# CLOVERLEAF FILING 2

# STORM SEWER AND POND PLANS

AS-BUILTS  
05/24/2023  
SF-21-023

# V1\_As-Built Construction Drawing.pdf Markup Summary

**POND 2 NORTH FOREBAY PLAN VIEW**  
SCALE: 3/8"=1'

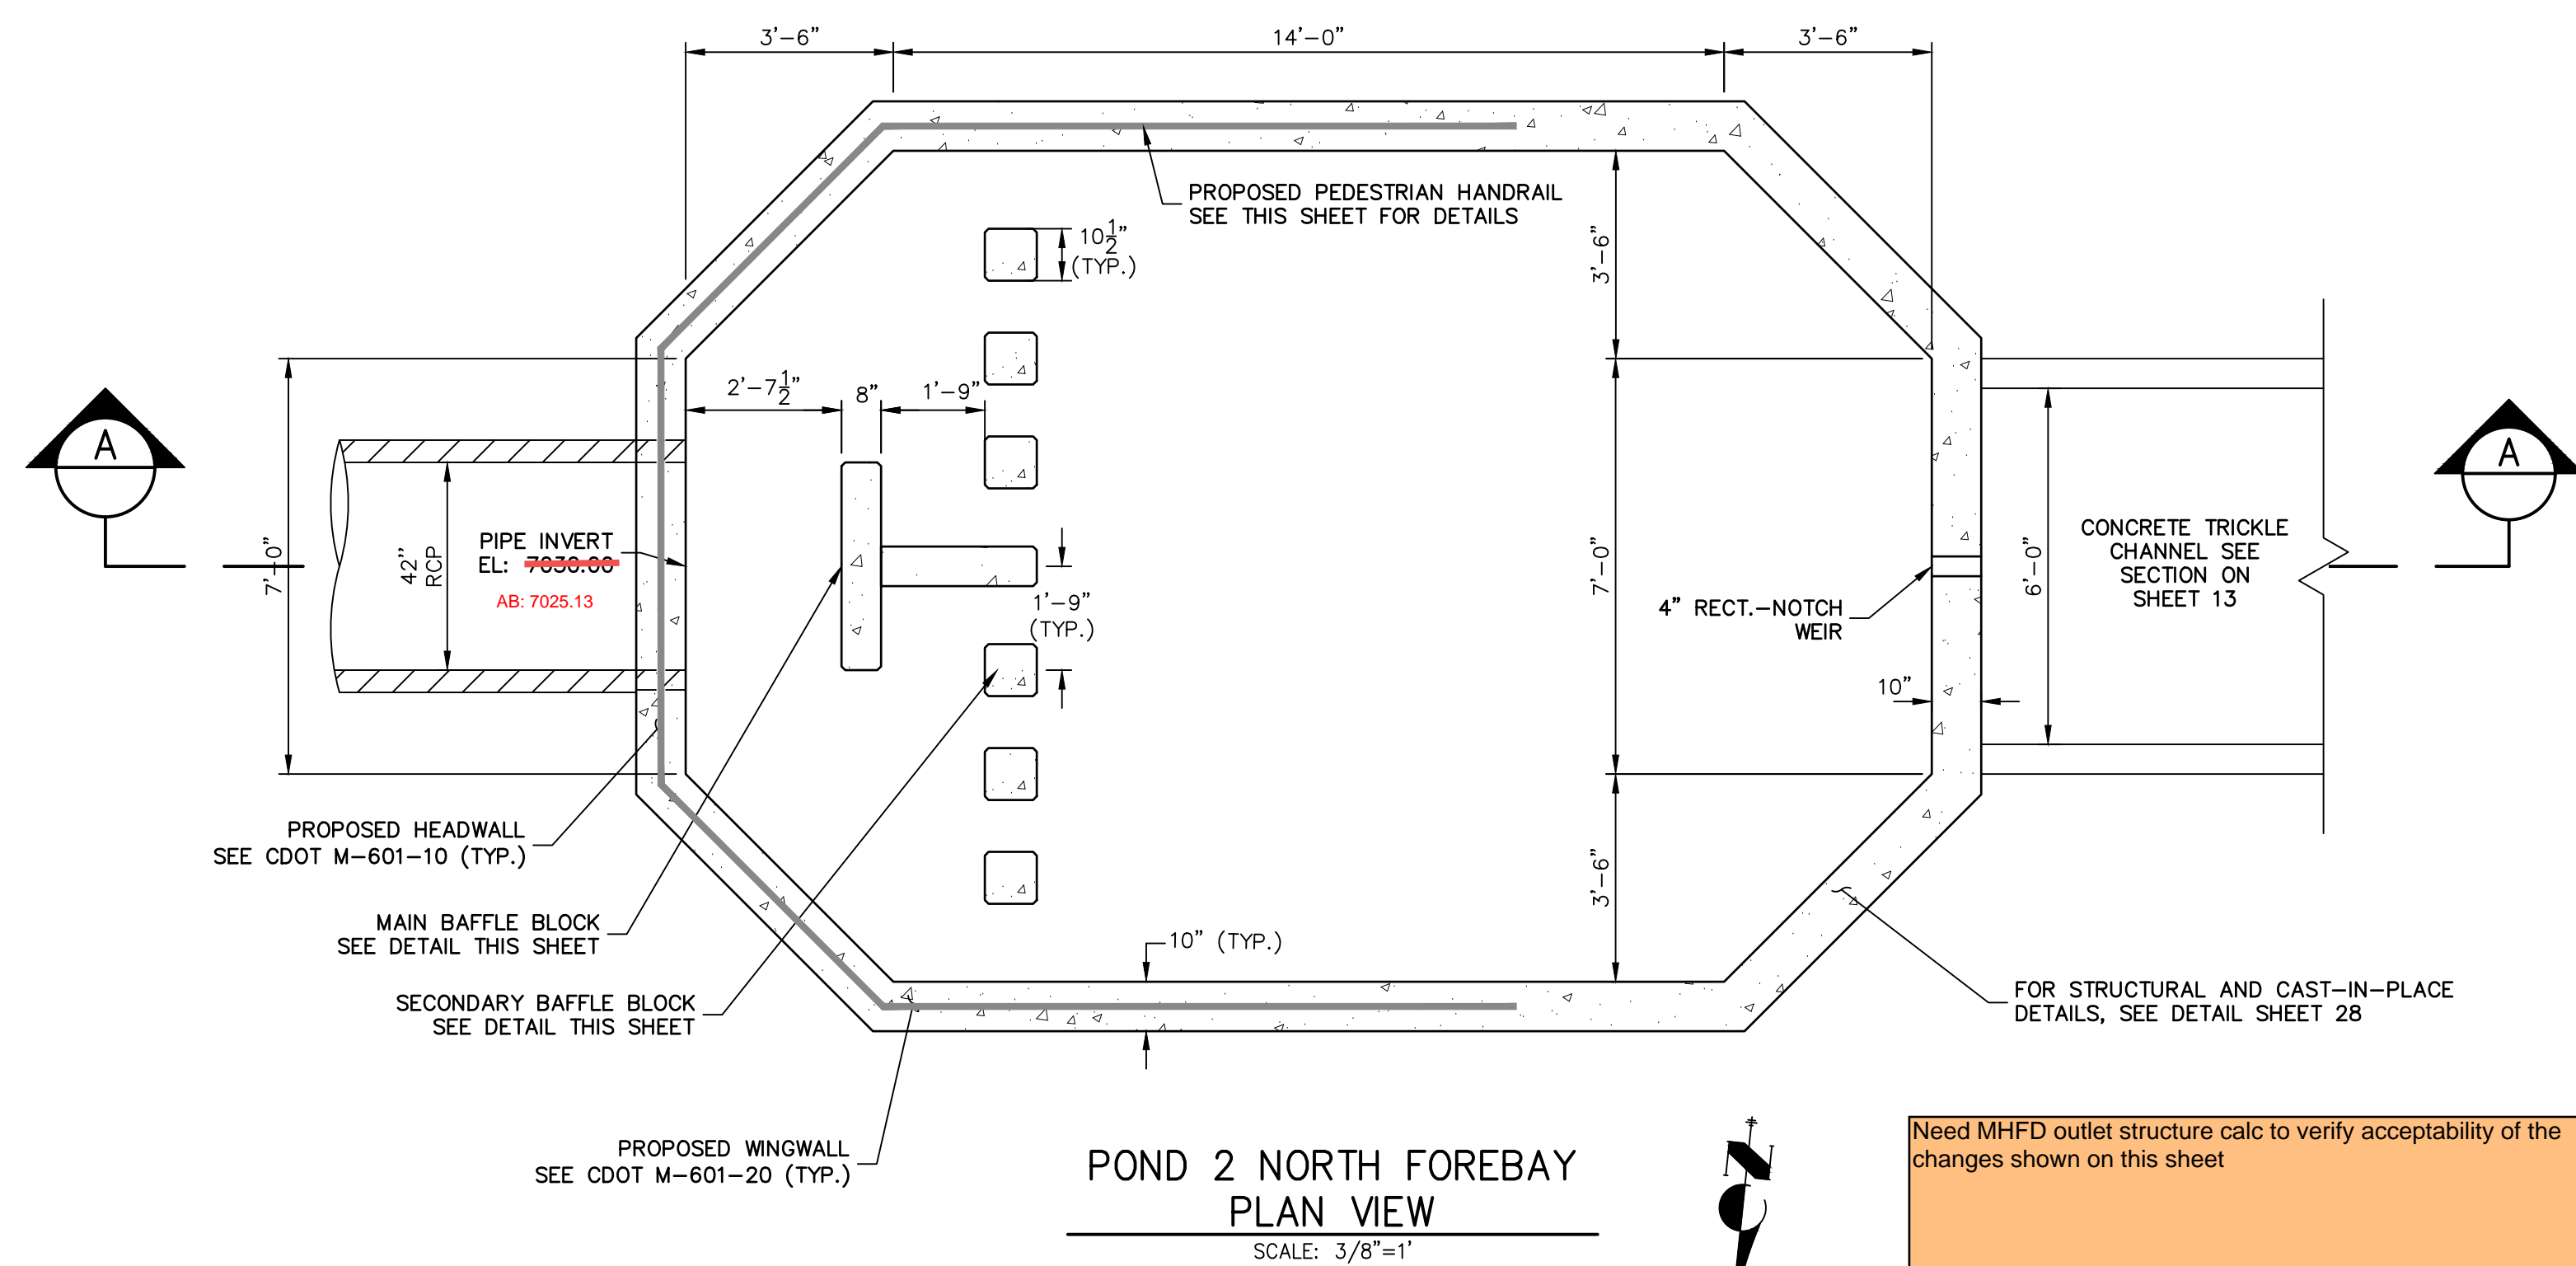
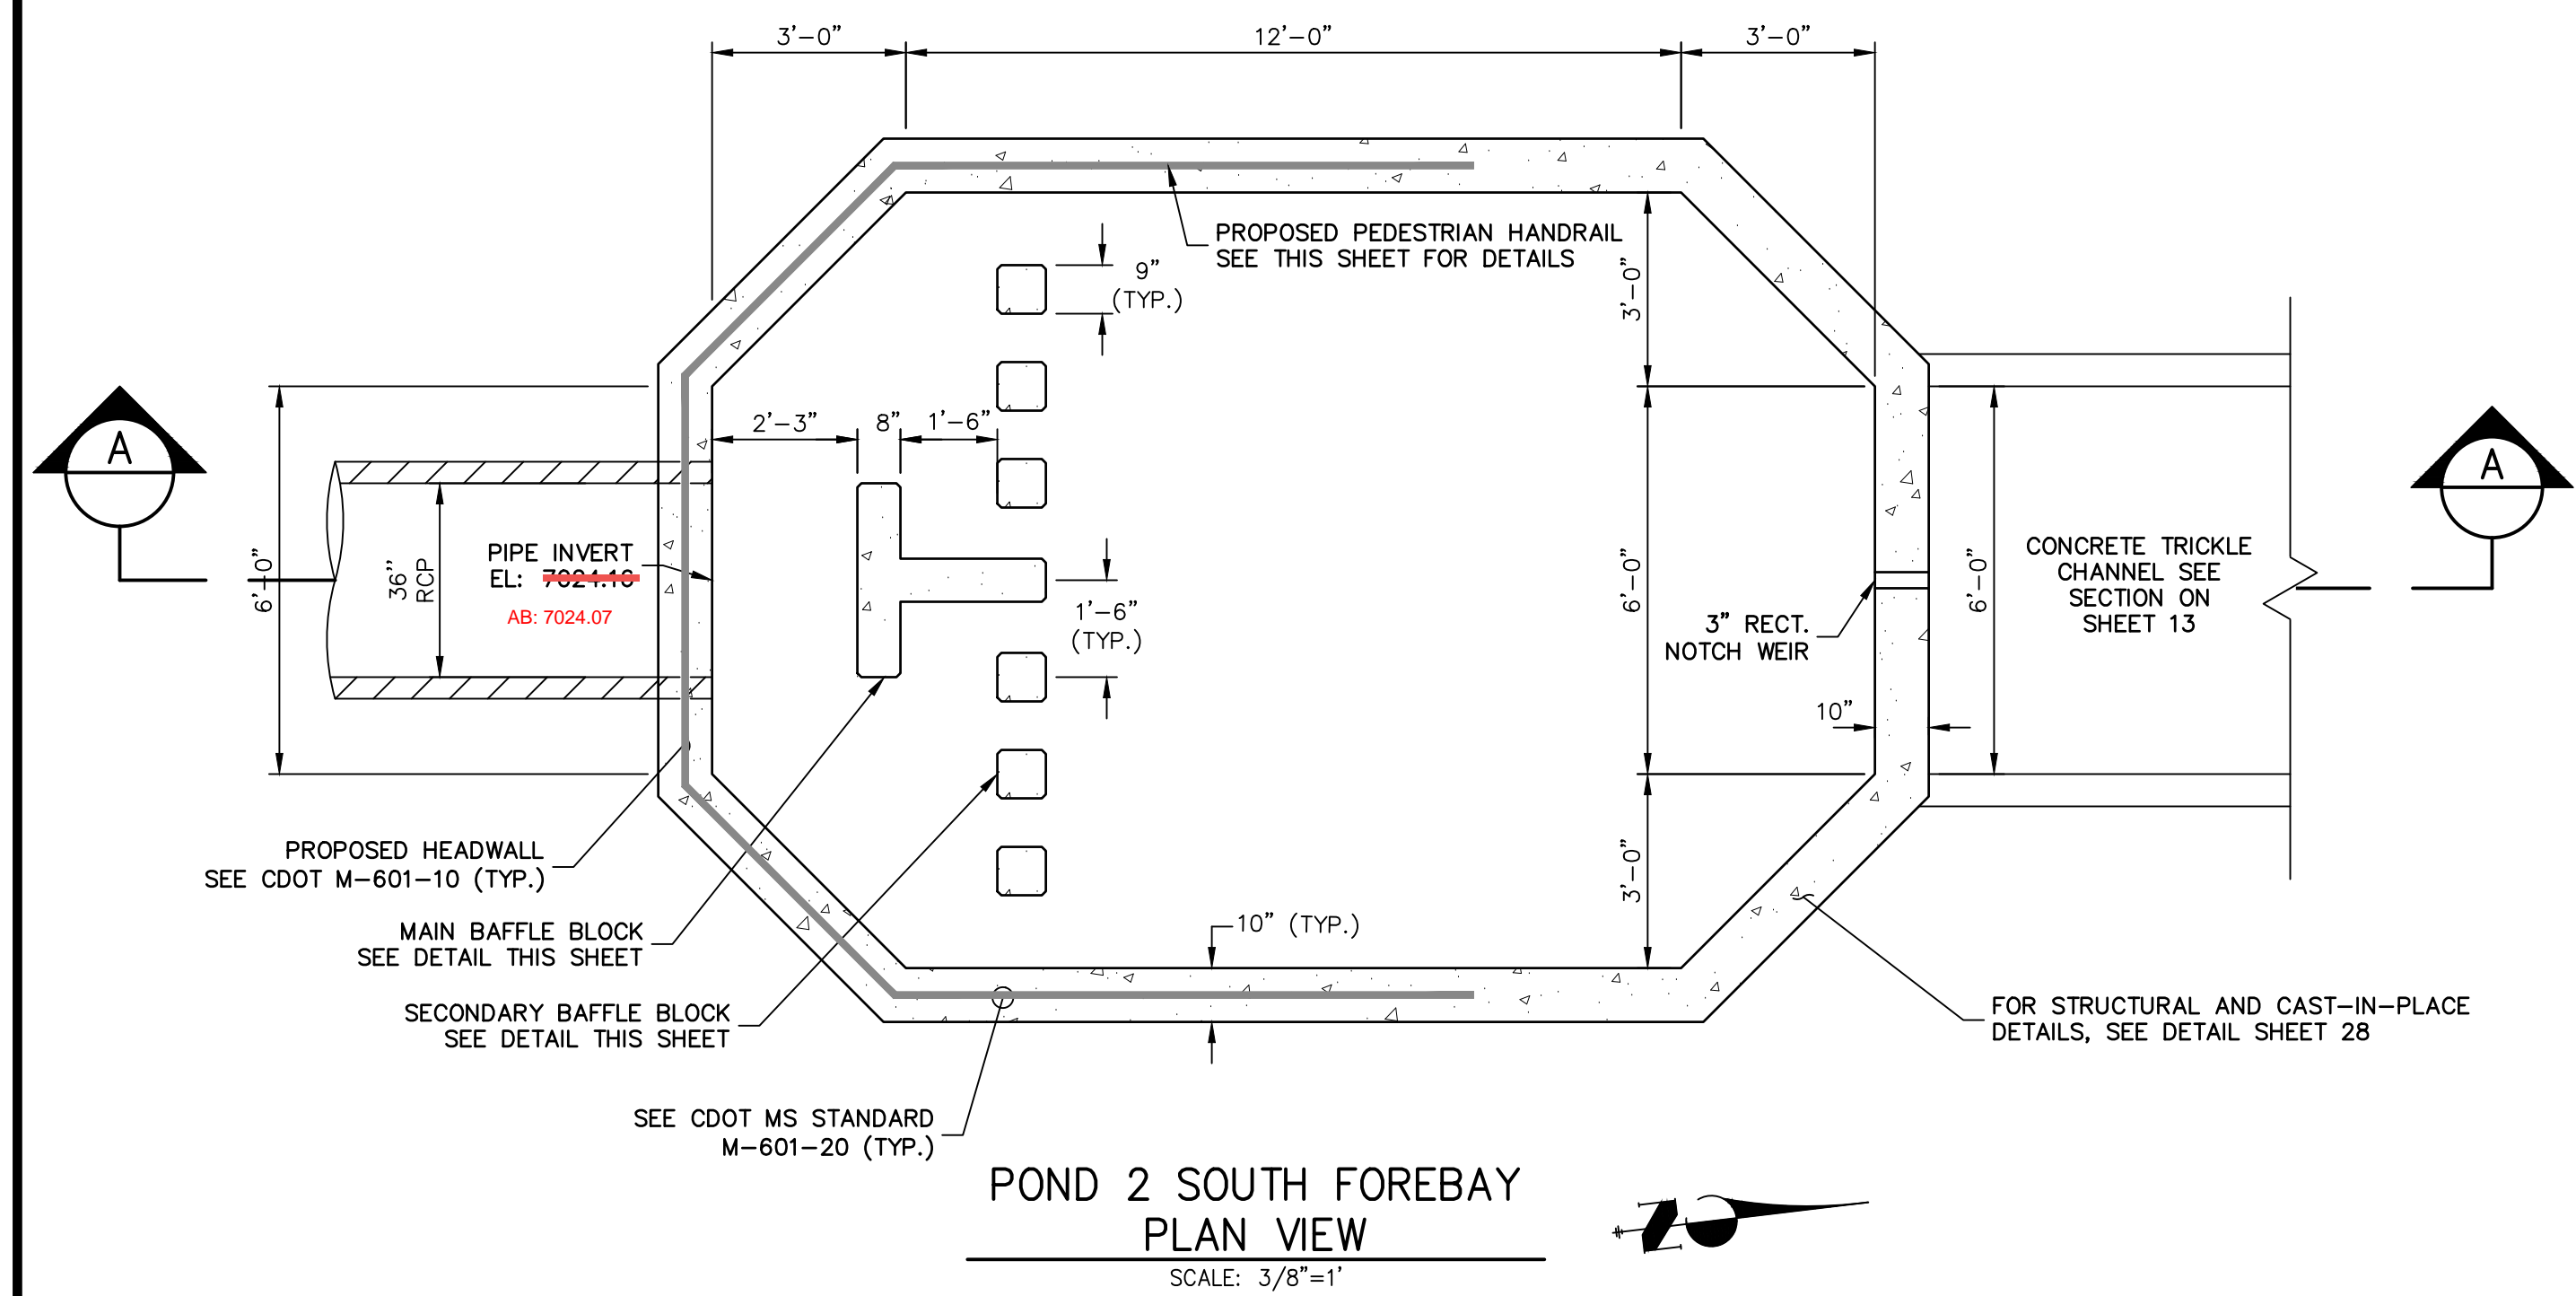
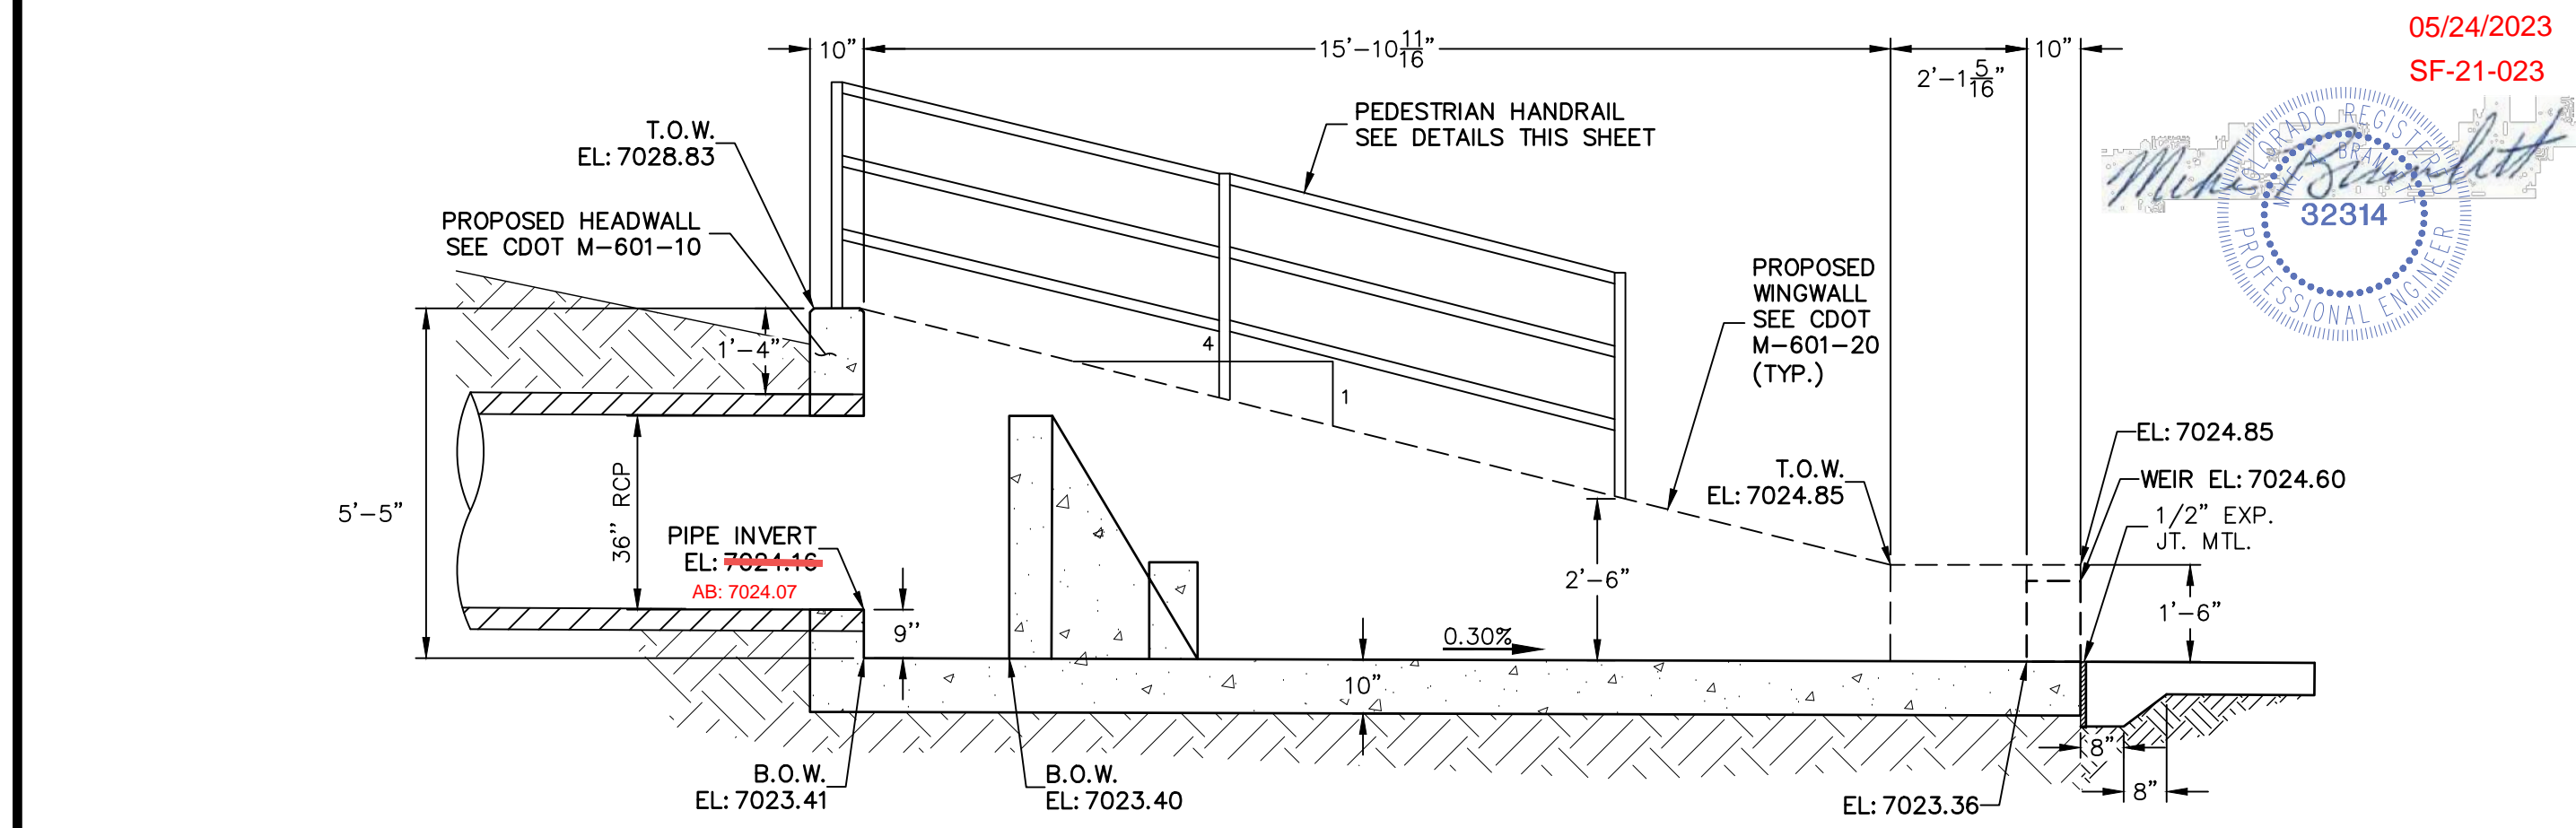
Need MHFD outlet structure calc to verify acceptability of the changes shown on this sheet
